# 802.1aj Two-Port MAC Relay Editor's report

John Messenger, November 2008

# D3.1 WG recirculation ballot results

Figure K-2—TPMRs with aggregated links

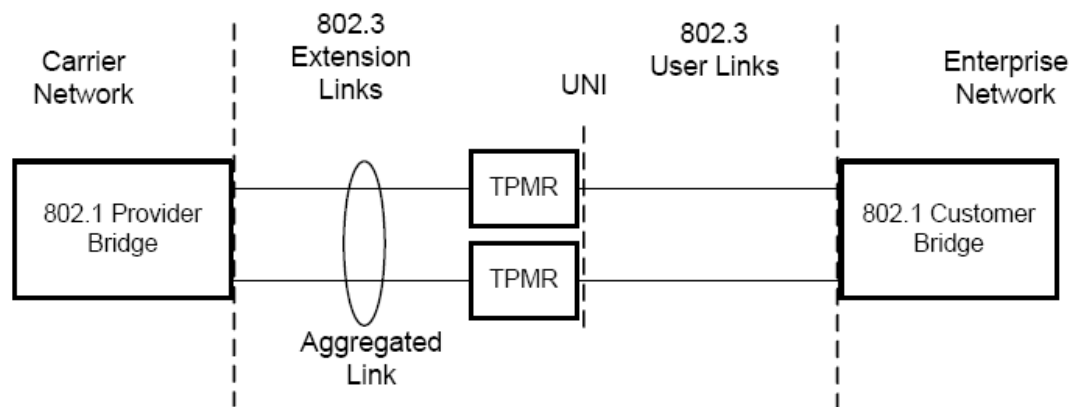
- ▶ Use case K.2 shows two TPMRs in LAG links. This conflicts with the addresses in table 8-3.
- ▶ Comments
  - ▶ Stephen Haddock #16
